3442 Gunston Road – Retaining Wall/Patio Hearing Resolution Worksheet

Appeal to Board of Covenants Approval Denial for 3442 Gunston Rd

COVENANTS APPLICATION FOR NON-ROUTINE CHANGES

Covenant Info for Retaining Wall and Flagstone Patio – 72906 – 3442 Gunston

DIAGRAM BLDG. 729 72906 3442 GUNSTON

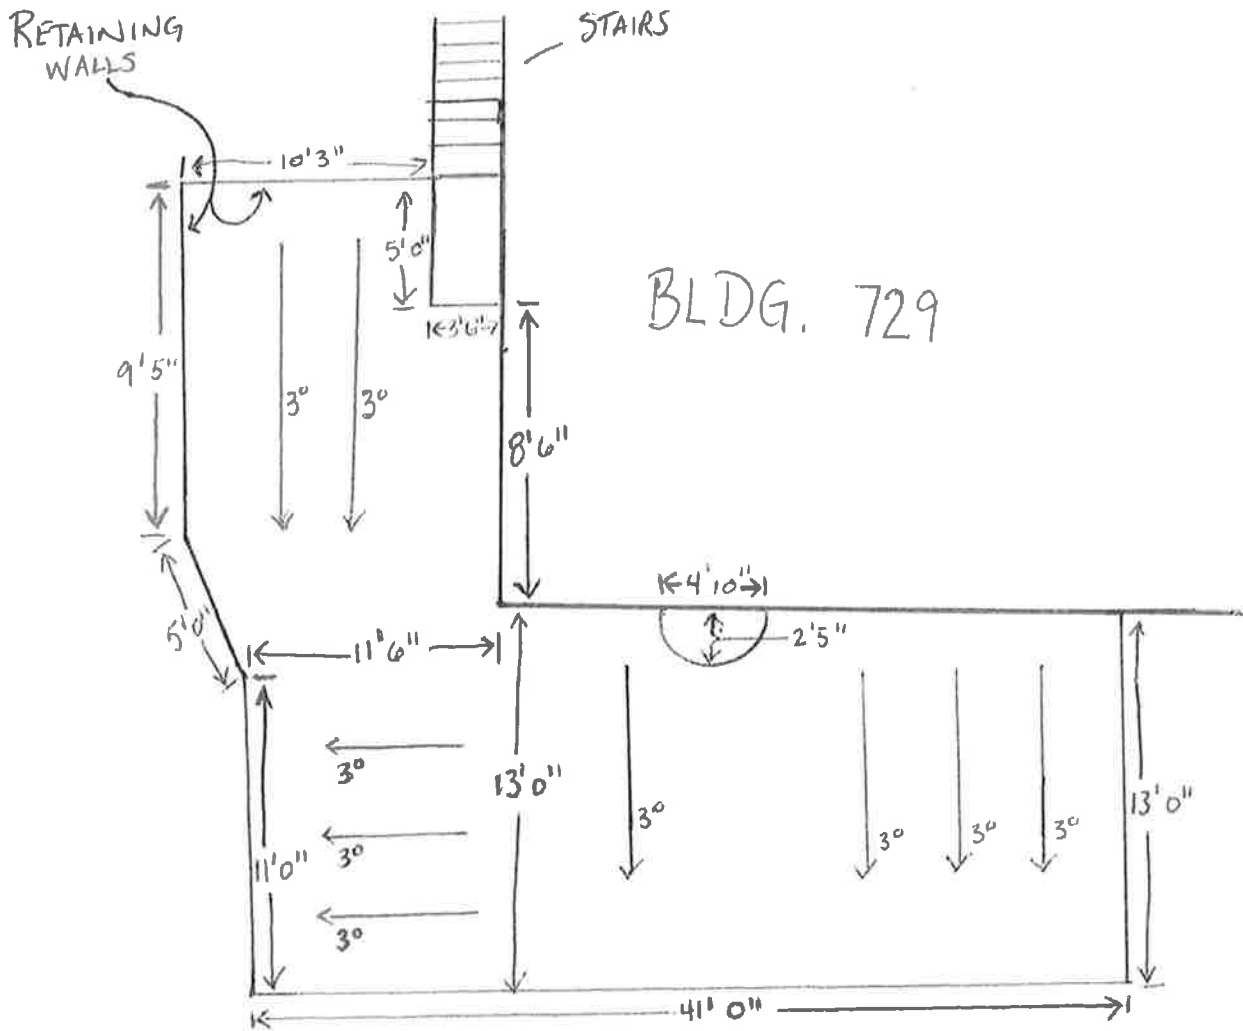
Stipulations/Reason for Denial: Patio/retaining wall does not comply
with current patio specifications. Patio extends
beyond the length of the building
